Description of Revisions: *This bulletin replaces the previous version dated October 1997. The list of affected vehicles has been clarified to include vehicles built from August 15, 1997 through July 9, 1998, with engines rated 500 horsepower or greater, and equipped with certain Horton fan drives.*

General Information

Fig. 1, Horton Fan Clutches

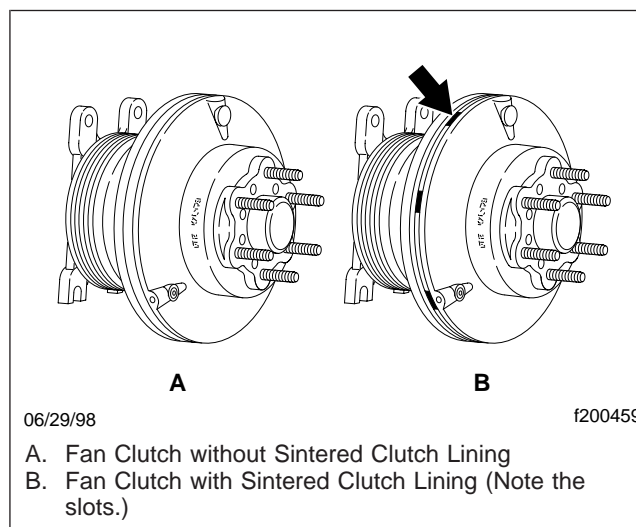
Horton fan clutches with 32-inch 9-blade fans deliver extra cooling power. Therefore, more torque is required from the fan clutch. If a vehicle is dyno tested or otherwise subjected to extended fan-on times early in its service life, the clutch lining may not be broken in properly, leaving it susceptible to slippage. This slippage can create heat, resulting in a blown Horton System Sentry plug.

As of July 10, 1998, all production plants have been installing Horton fan clutches with a sintered clutch lining on engines rated at 500 horsepower or greater. See **Fig. 1**. This lining is better suited to handle the increased torque from the 32-inch fan.

If the System Sentry plug blows or there are other signs of excessive fan clutch heat or slippage, first check for correct fan control operation and air leaks. If all checks okay, install the sintered clutch lining. For instructions, see *Group 20* of the **Heavy-Duty Trucks Service Manual**, the **Business Class Trucks Service Manual**, or the **Century Class Trucks Workshop Manual** for fan clutch disassembly and assembly. In addition to the sintered lining, a seal kit will also be required for reassembly. See **Table 1** for parts needed.
